## **RESPONSE TO COMMENTS The Reserve at Lake Ridge TIA**

The following is our response to review comments concerning the Reserve at Lake Ridge TIA. Each of the comments is listed first in **bold** followed by our response.

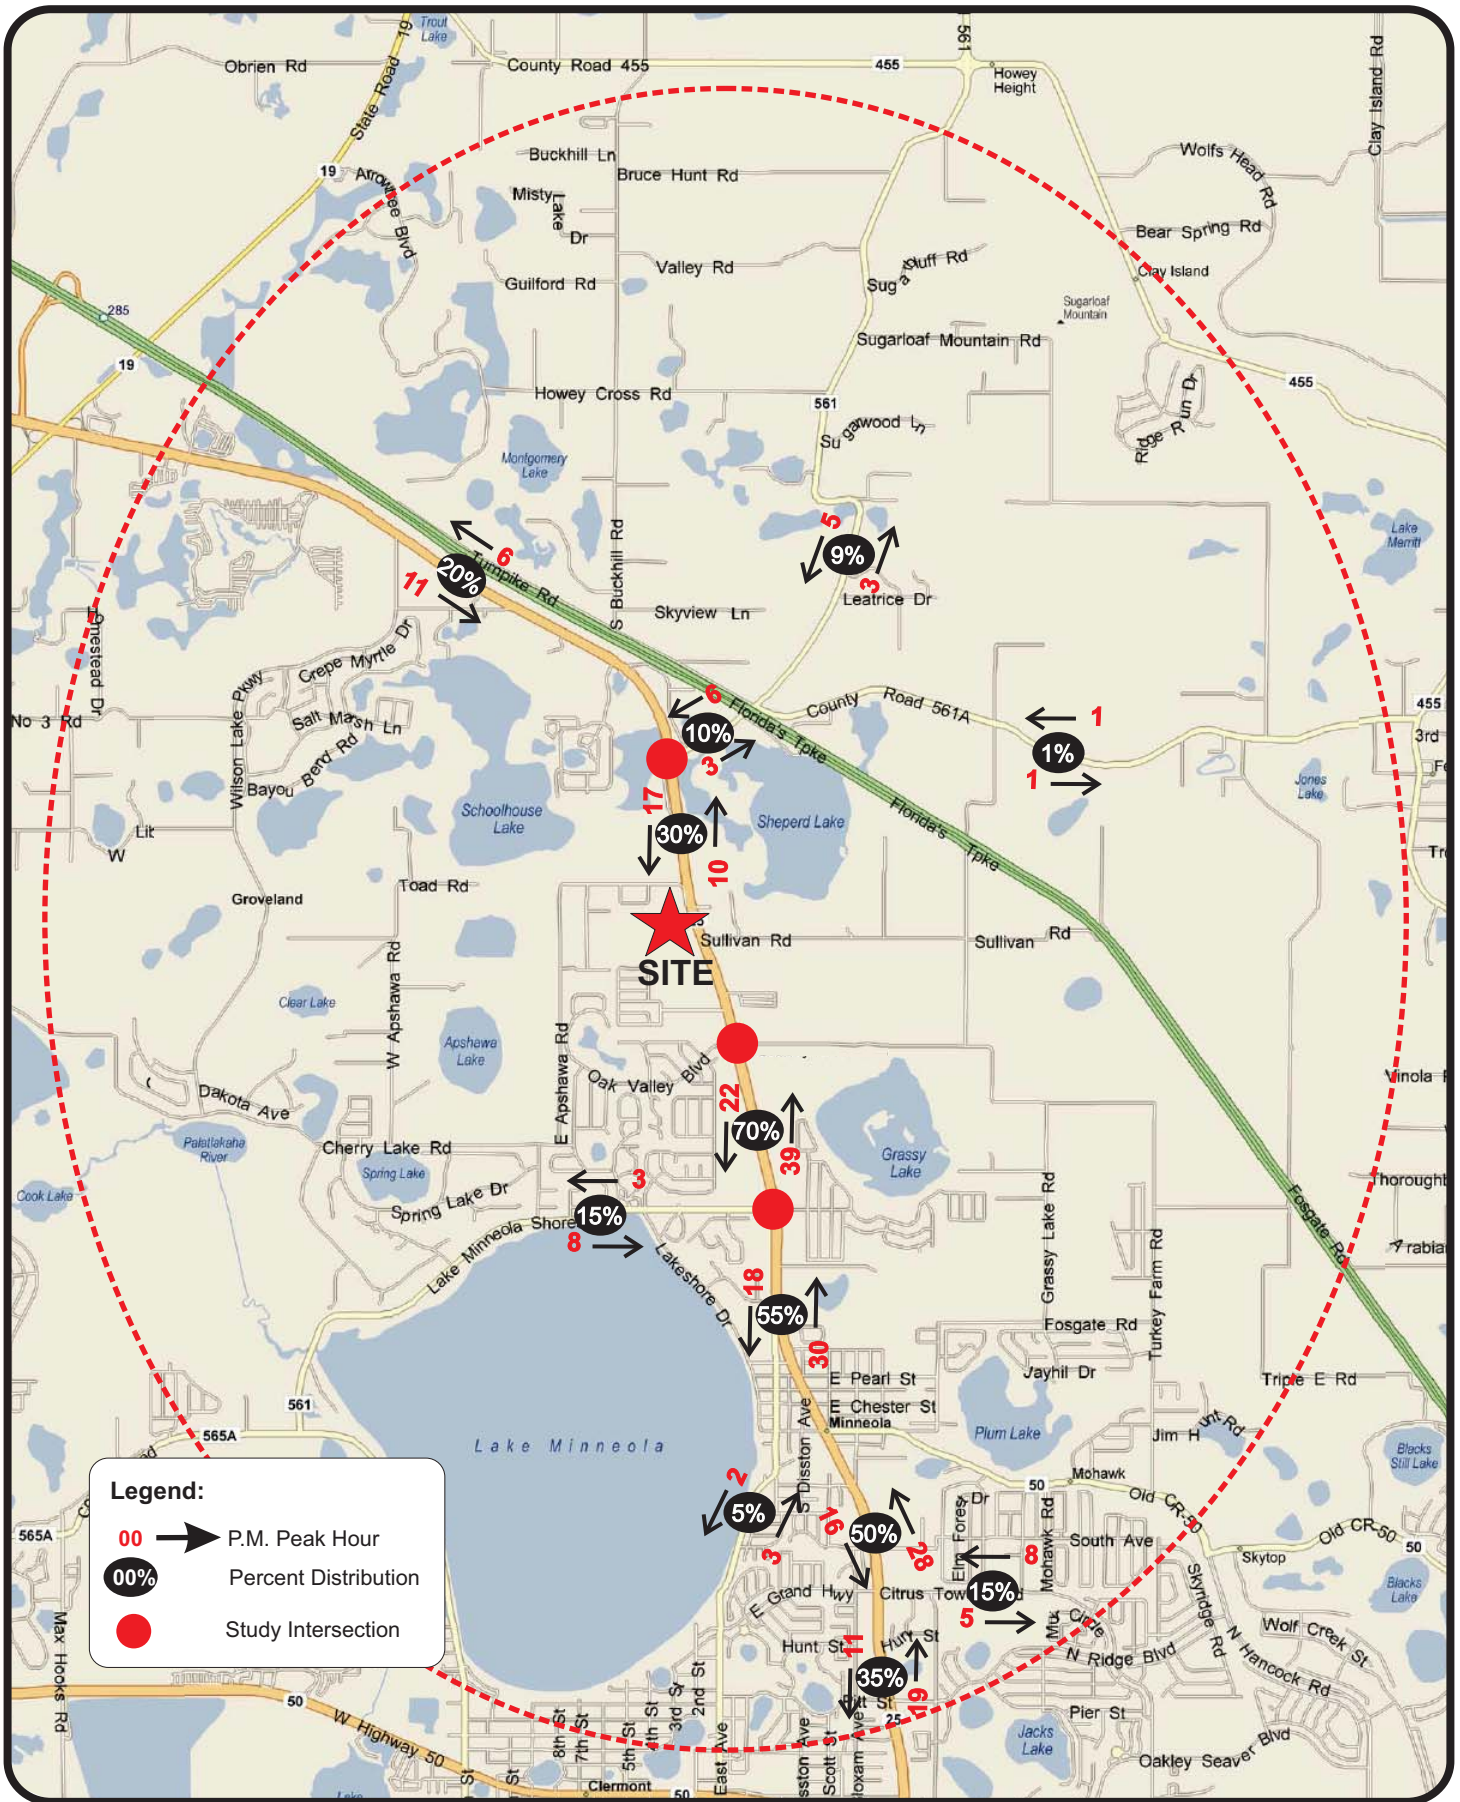
- **Future roadway geometry, including the access configuration and new construction on US 27, should be included in the introduction.**

The conceptual plan shows the right and left turn lanes proposed at the project's access location. In the conclusions, the same is reiterated. The turn lanes will be constructed as per FDOT Design Index 301.

The Reserve at Lake Ridge  
 Project No 4774  
**Figure 4**

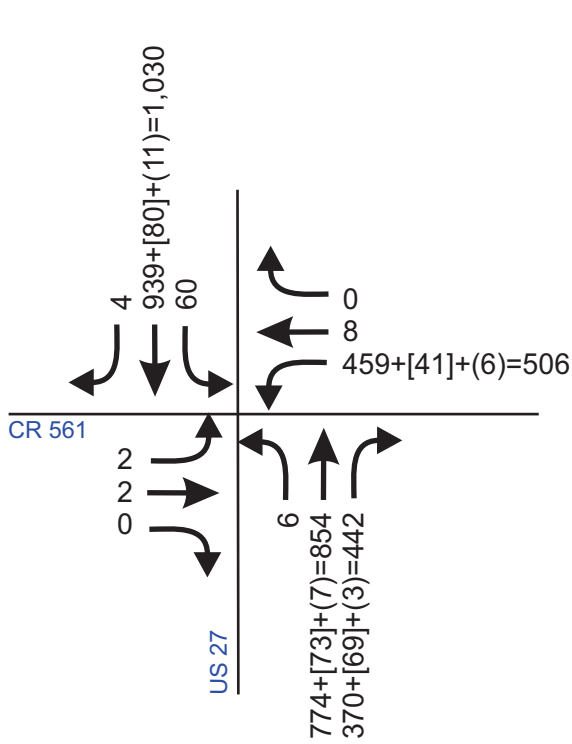
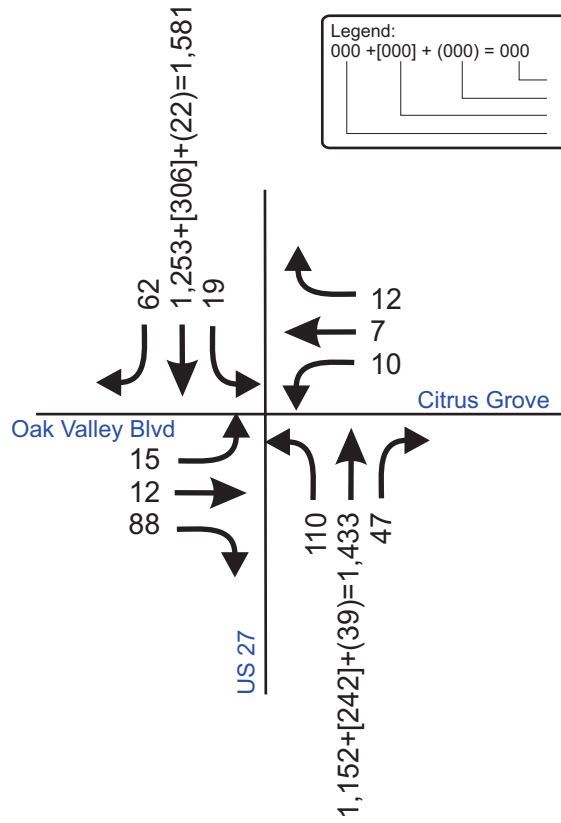
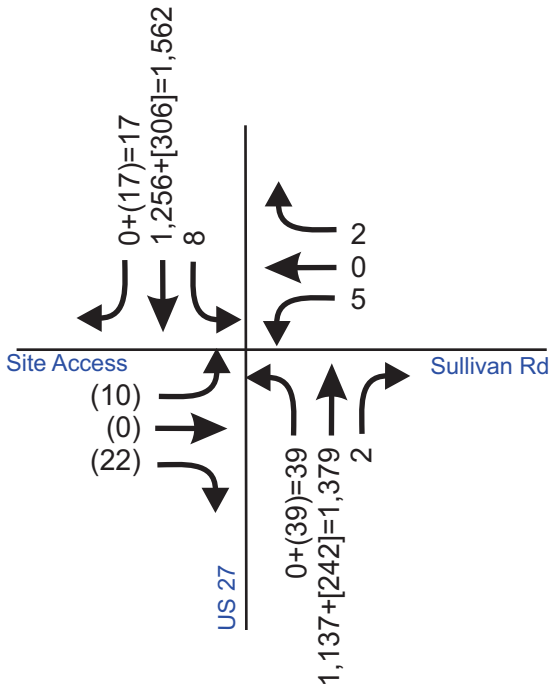
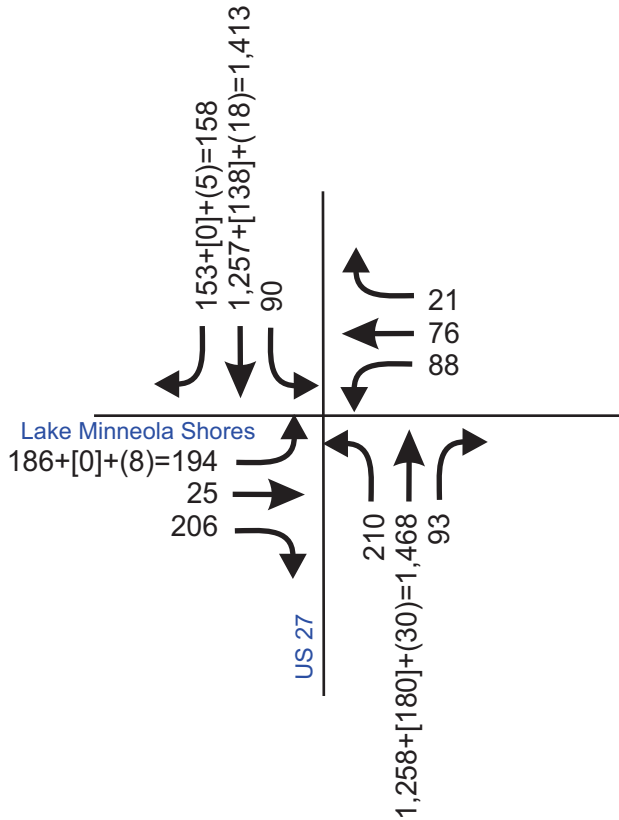
- **Clearly label the study intersections on Figure 4.**

- **The trip assignment on Figure 4 does not balance between intersections. For example, there are 22 southbound trips assigned to US 27 north of Lake Minneola Shores, but only 21 trips (3 on westbound Lake Minneola Shores and 18 on US 27 south) depart from the US 27 / Lake Minneola Shores intersection. Likewise, there are 30 northbound trips on US 27 south of Lake Minneola Shores and 8 eastbound trips on Lake Minneola Shores approaching US 27, but only 29 trips on northbound US 27 downstream of Lake Minneola Shores. Please revisit the trip assignment at all study intersections.**

- **It is unclear how the trip assignment in Figure 4 translates into the assigned trips in Figure 5. For example, there are no project trips assigned to northbound US 27 at the site access. Please revisit the future traffic volume development at all study intersections.**

Although the study intersections are not labelled in Figure 4, they are listed on page 3 of the report. However, US 27 and the roadways forming the study intersections are labelled in the figure.

A typographical error has created the confusion that resulted in this comment. The project trips shown on US 27 between Lake Minneola Shores and Sullivan Road is 39 and not 29. A further confusion was created in Figure 5 at the site access where the 39 project trips were identified as committed trips [in brackets] and not as project trips (in parentheses). We have reviewed the trip assignment at all study intersections and we can confirm that the correct trips were used in the analysis. In some instances, there may be a difference of one (1) trip from one segment to the next due to rounding. Revised Figures 4 and 5 are attached.
